Minutes of 102nd PCC Meeting

EASTERN REGIONAL POWER COMMITTEE

MINUTES OF 102ND PROTECTION SUB-COMMITTEE MEETING HELD ON 13.05.2021 AT 10:30 HOURS

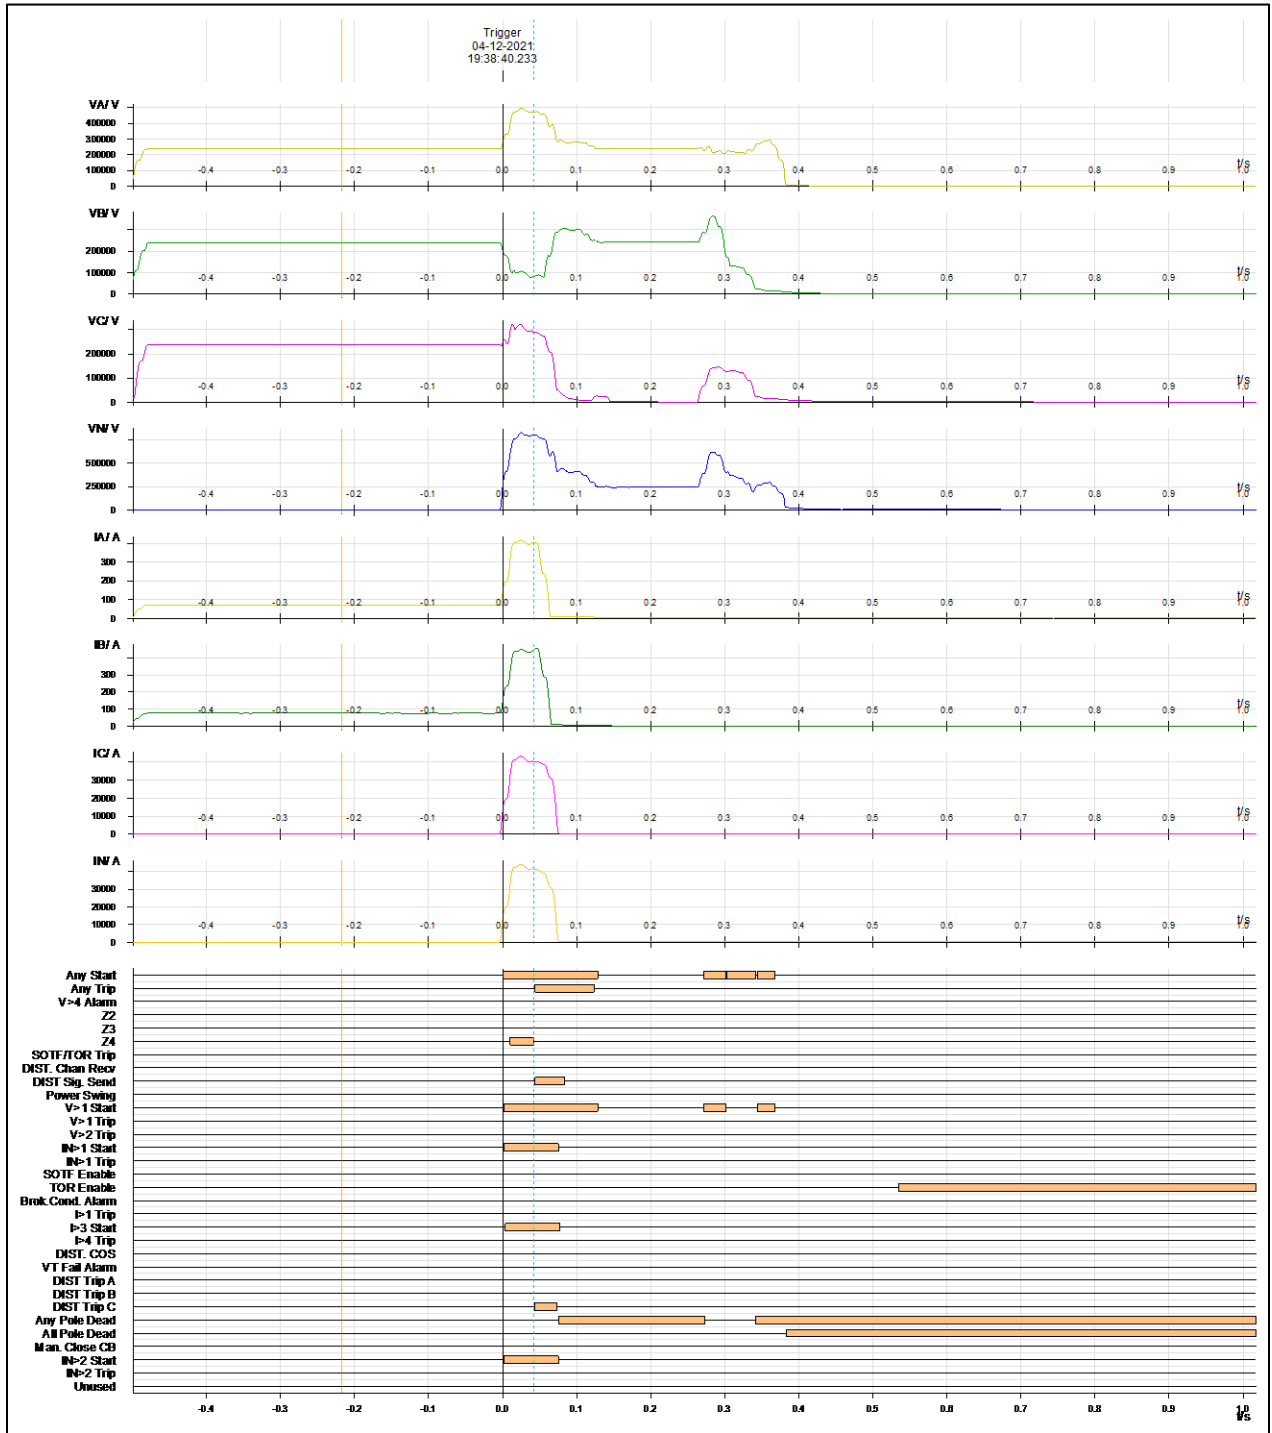
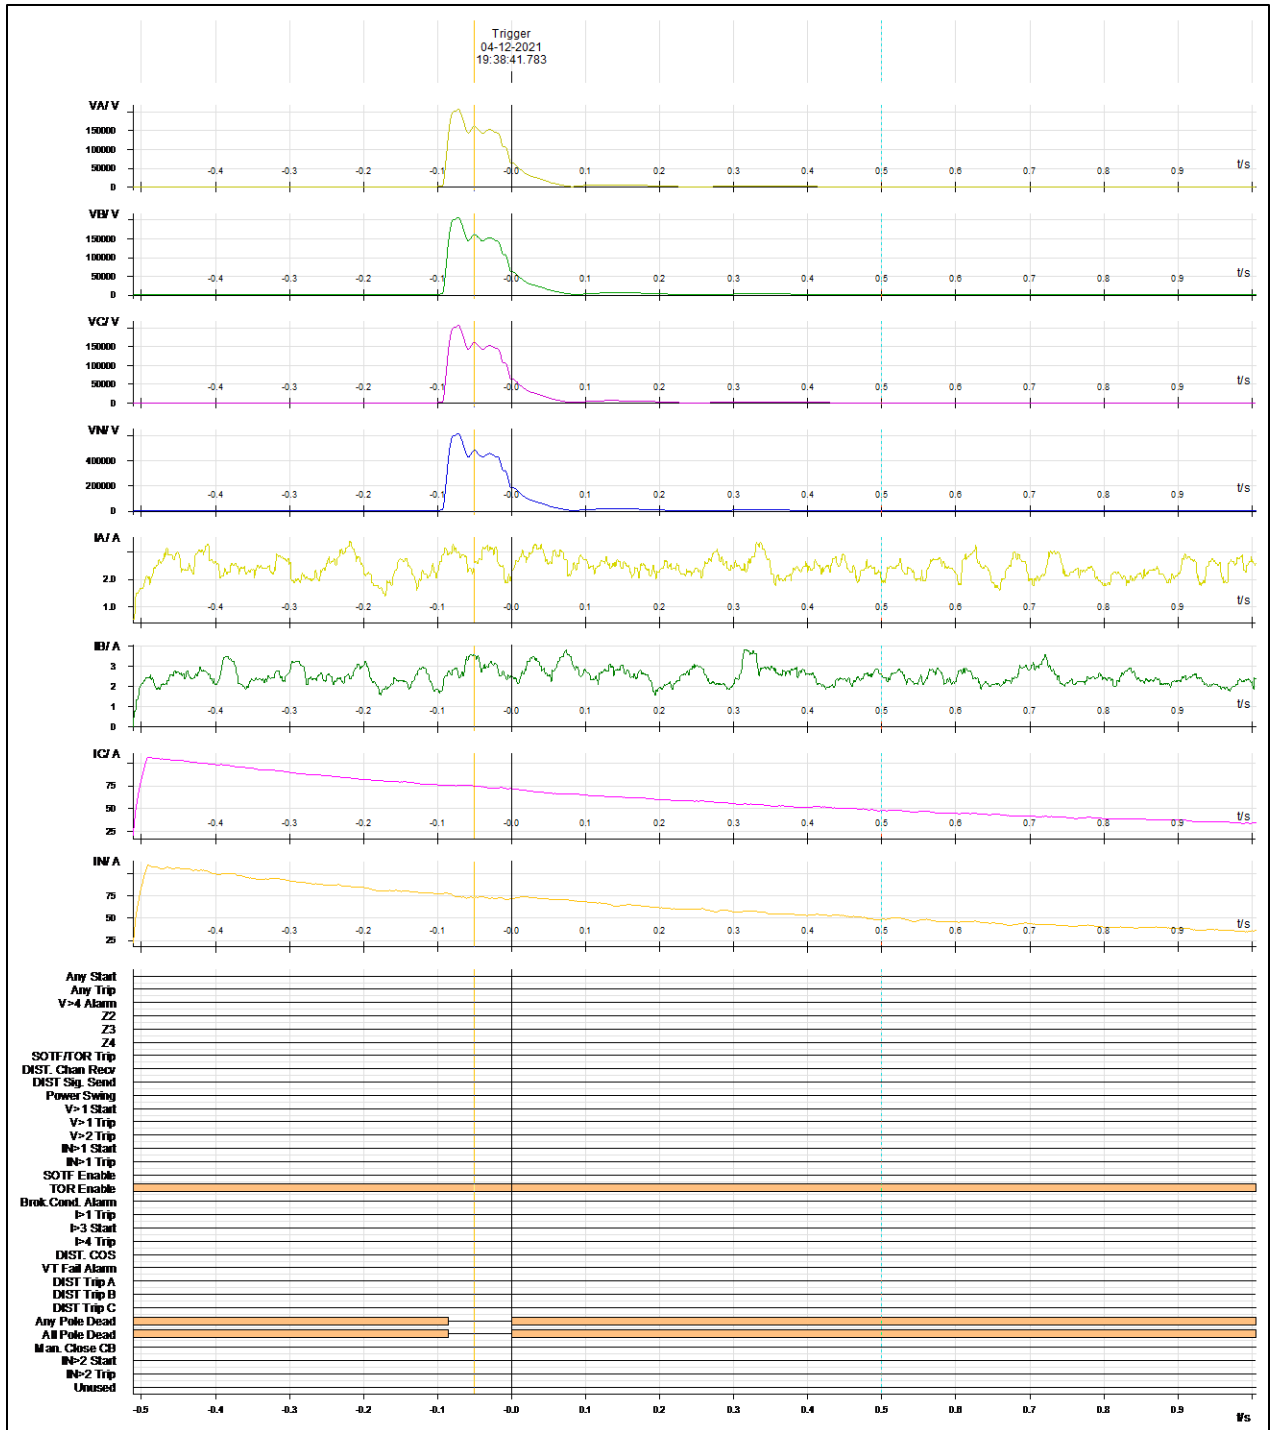
Line voltage in all three phases reappears for around 100 ms around 1.5 seconds after the three poles tripping at Farakka on zone - 4. Current was zero at that time at Farakka end. DR is not time synchronized.

Annexure 4: DR recorded at Purnea end for 400 kV Farakka New Purnea – 1

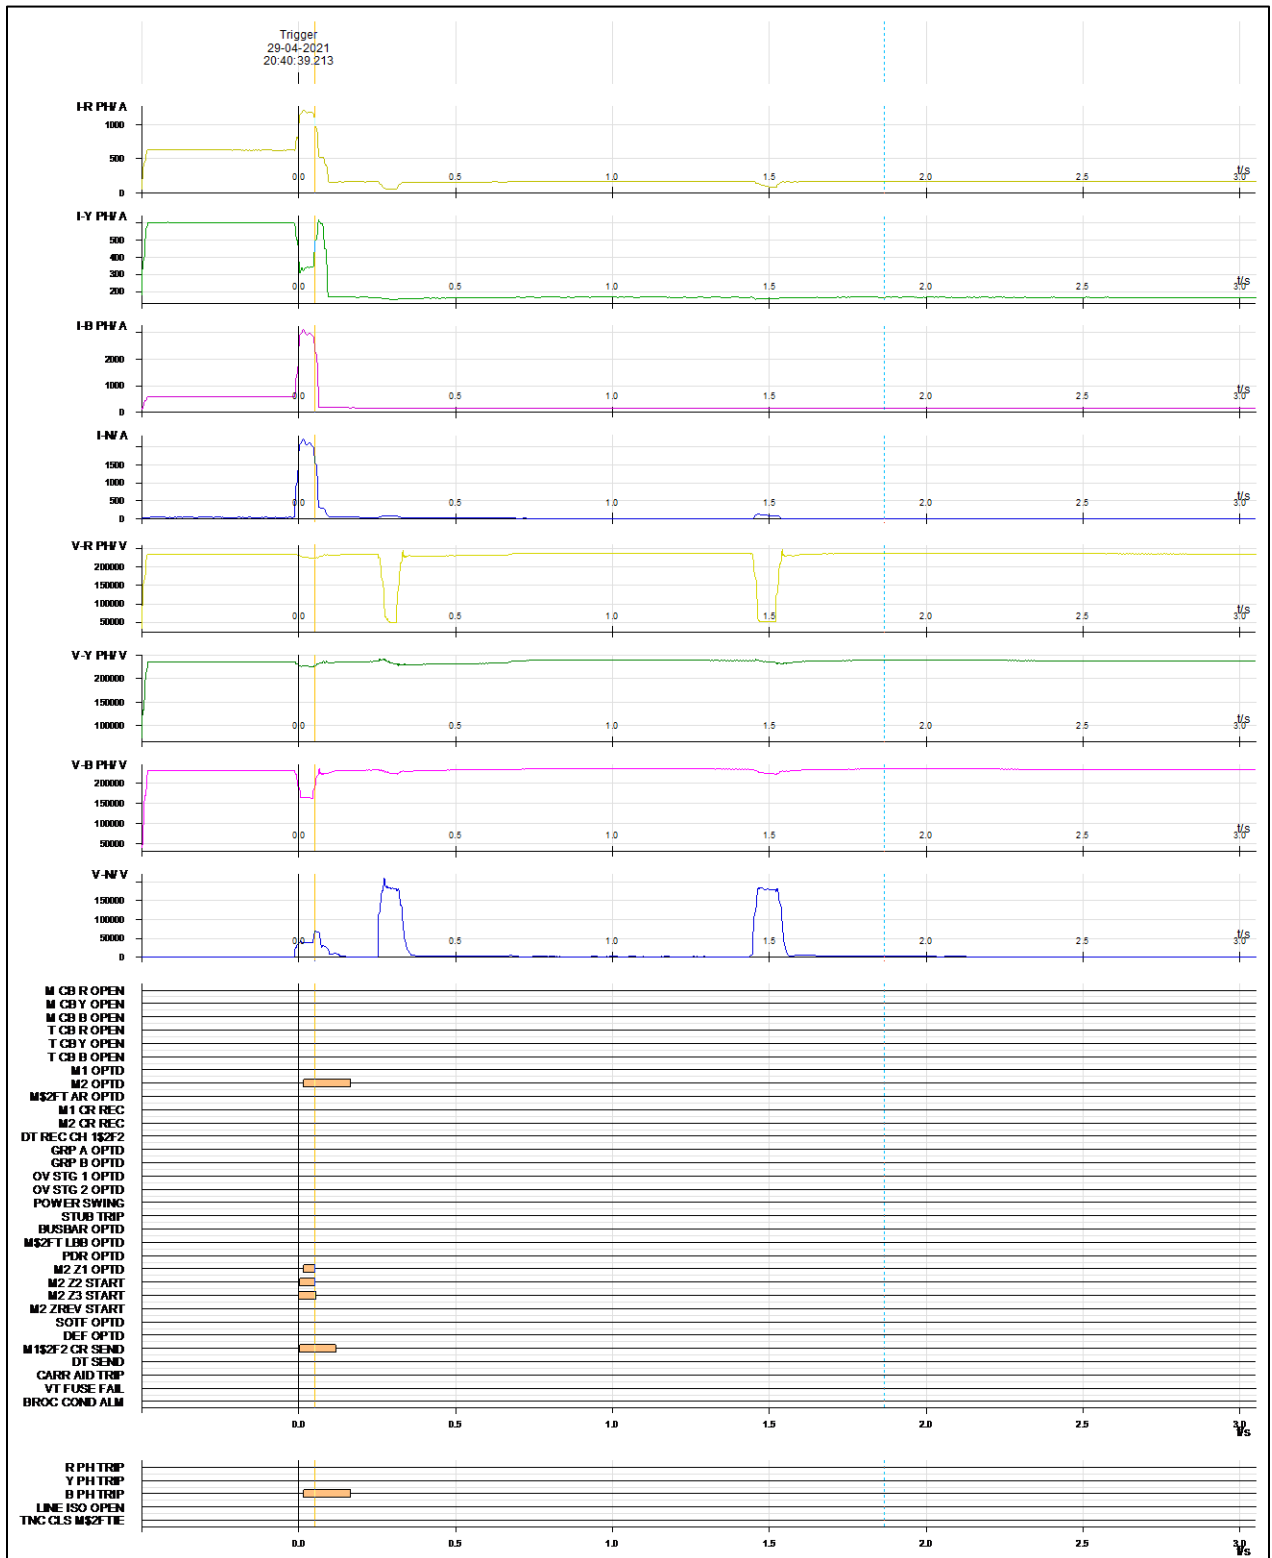
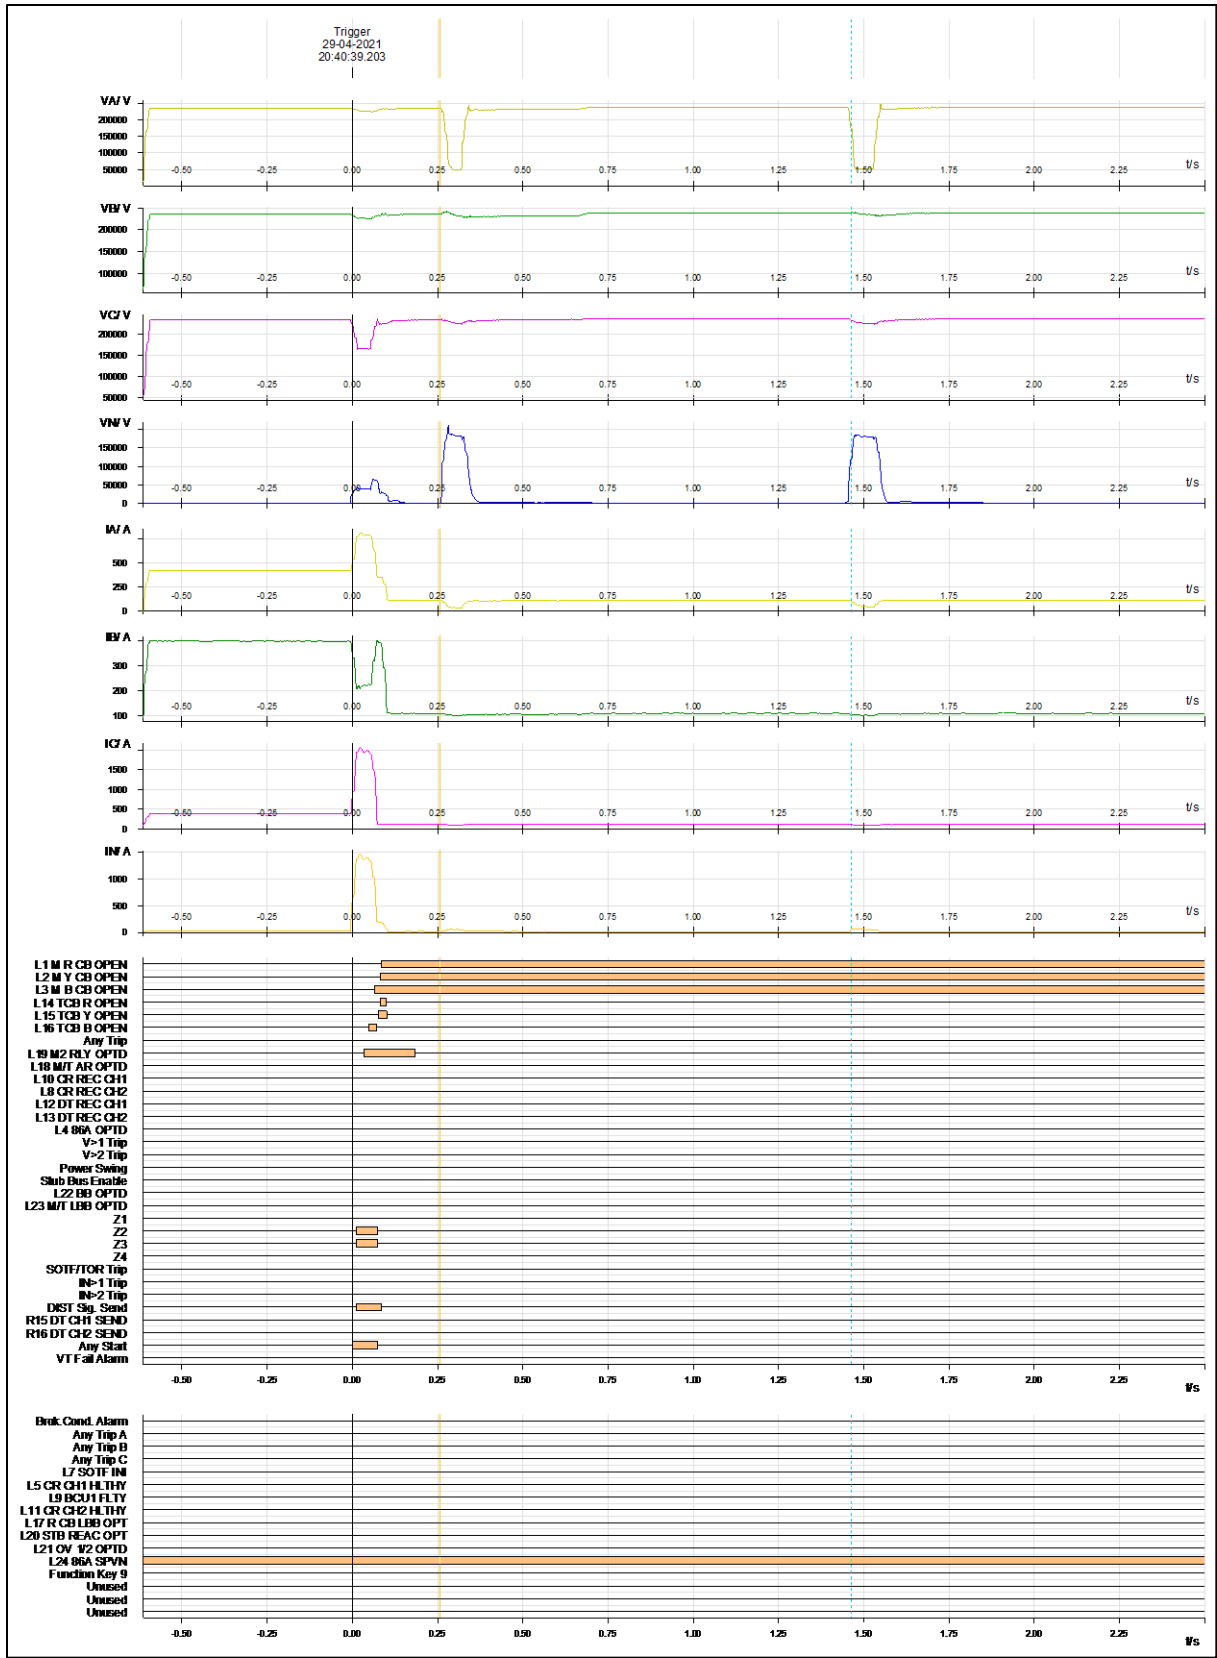
Fault was sensed in zone – 1; Unsuccessful auto-reclose operation.
